MEETING NOTES
Waste Management Area C RCRA Facility Investigation Report

MEETING DATE: April 21, 2016
LOCATION: Washington State Department of Ecology Office, Richland, WA
ATTENDEES:

BACKGROUND INFORMATION: The meeting was called to promote continued Ecology, EPA, DOE, and WRPS discussion about comments associated with and revision of RPP-RPT-58339, Rev. A Draft *Phase 2 RCRA Facility Investigation Report for Waste Management Area C* (WMA C RFI Report). The report was submitted to Ecology and EPA in December 2014 to meet *Hanford Federal Facility Agreement and Consent Order* (HFFACO) Milestone M-045-61. Ecology's February 23, 2015 response to the RFI report submittal (Letter 15-NWP-37) noted that holding "a recurring meeting to discuss statements, regulatory interpretations, and the process steps for obtaining an agreeable RFI/CMS process for WMA C Closure" would be beneficial. Ecology comments on the WMA C RFI Report and supporting documents were transmitted on July 7, 2015, "Department of Ecology's (Ecology) Completed Review of Phase 2 RCRA Facility Investigation Report for Waste Management Area C, RPP-RPT-58339, Revision A Draft" (15-NWP-120).

Figure 3-1: Human Health Conceptual Exposure Model

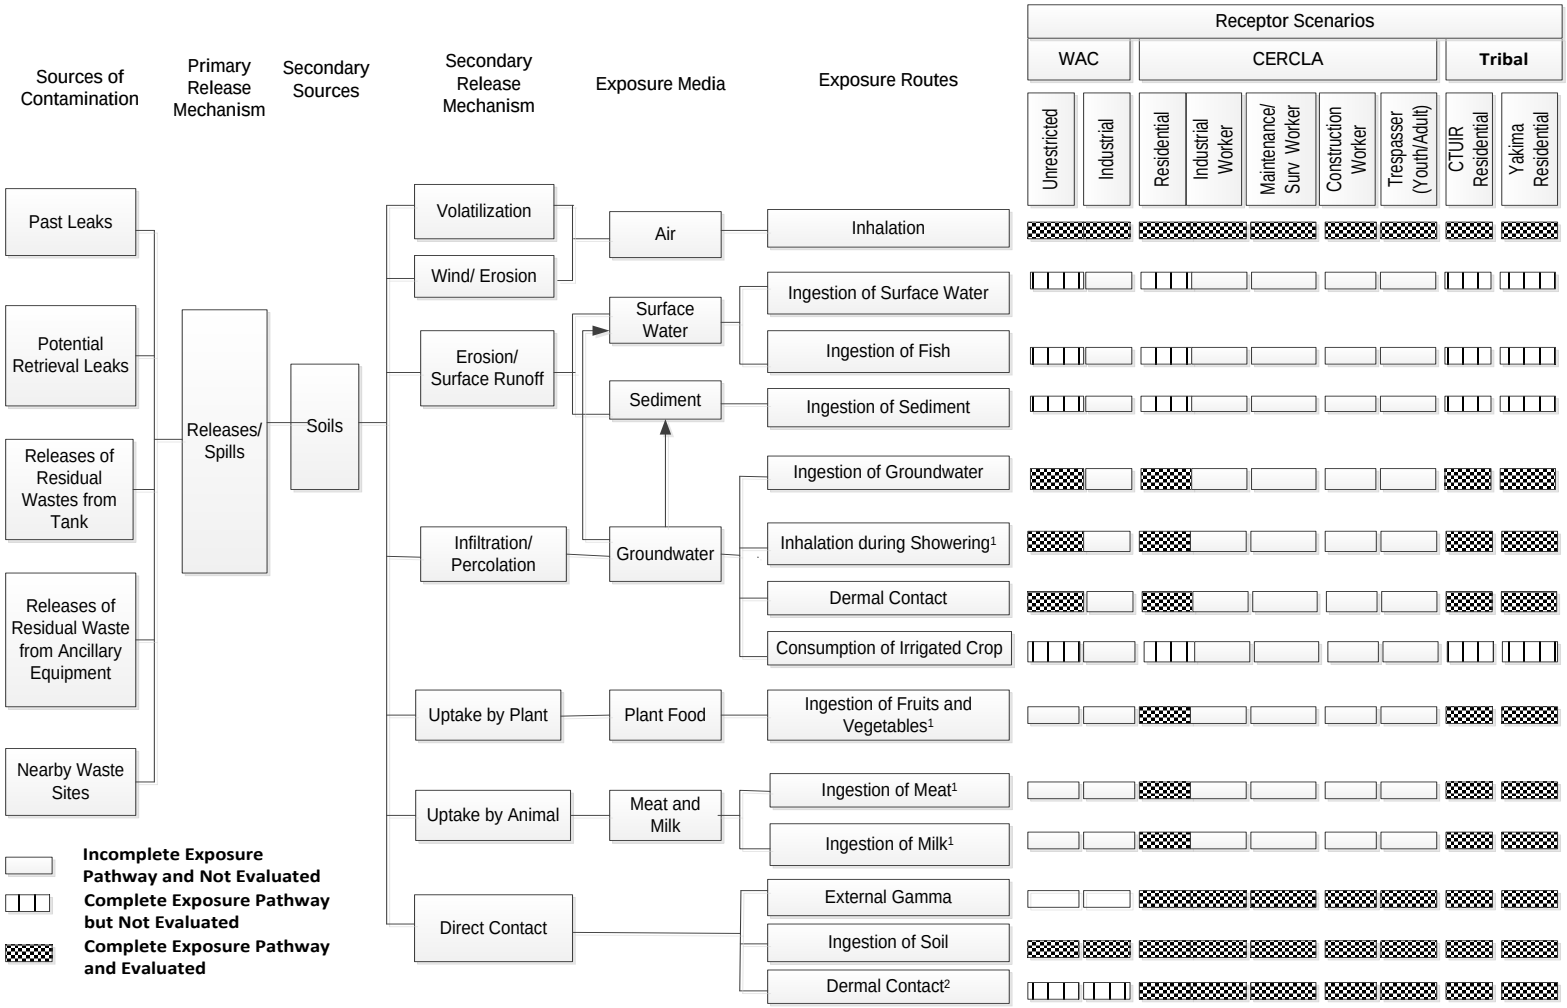
Damon BRA 12: **Tentatively Agreed Pending Modification**. Dr. Delistraty tentatively agreed to the proposed revised response, pending modification to BRA Figure 3-1 and incorporation into the

revised BRA. The figure should be modified to delete the superscript "1" from the exposure routes for ingestion of fruit, vegetables, meat, and milk. Superscript "1" should remain for the exposure route for inhalation during showering. The figure should also be modified to add a superscript "2" to the pathway for dermal contact coming out of the groundwater exposure medium.

Commenter	Item	Page #/ section # Line #	Comment & Basis/Justification	*Doc*	*Chapter(s)*	Response
Damon	12	P 3-9, Figure 3-1	For transparency, Figure 3-1 should be labeled as human health conceptual exposure model and should present all exposure pathways (even if all are not evaluated). Therefore, in addition to soil ingestion and soil inhalation, MTCA (WAC 173-340) includes soil dermal contact and soil contaminants leaching to groundwater with subsequent ingestion of groundwater by residential receptors. Also, CERCLA includes soil contaminants leaching to groundwater with subsequent ingestion of groundwater by residential and tribal receptors or other subsequent uses (e.g., showering, irrigation of crops). Contaminated groundwater may also impact fish in the Columbia River which may be consumed by residential or tribal receptors. **Email from Damon Delistry on 2/18/16, Subject Re: Updated BRA and RFI/BRA comments** *Damon BRA 12* The updated Figure 3-1 should be titled, "Human health conceptual exposure model." Footnote 2 applies to nonrad COPCs (not rads). Also, add contaminants transported from groundwater to surface water and sediment with subsequent ingestion of contaminated surface water, sediment, and fish by the WAC resident (unrestricted land use), CERCLA resident, and tribal receptors.	BRA		Figure 3-1 will be revised. The title of the Figure 3-1 will be labeled as "Human Health Conceptual Exposure Model" Three types of exposure pathways - (1) Complete and Evaluated; (2) Complete, but not Evlauated; and (3) Incomplete, hence not Evaluated will be included in the updated Figure 3-1. The pathways listed in the comments will be included as completed by not evluated. Text will be updated to state the reasoning for not evaluating those completed exposure pathways.
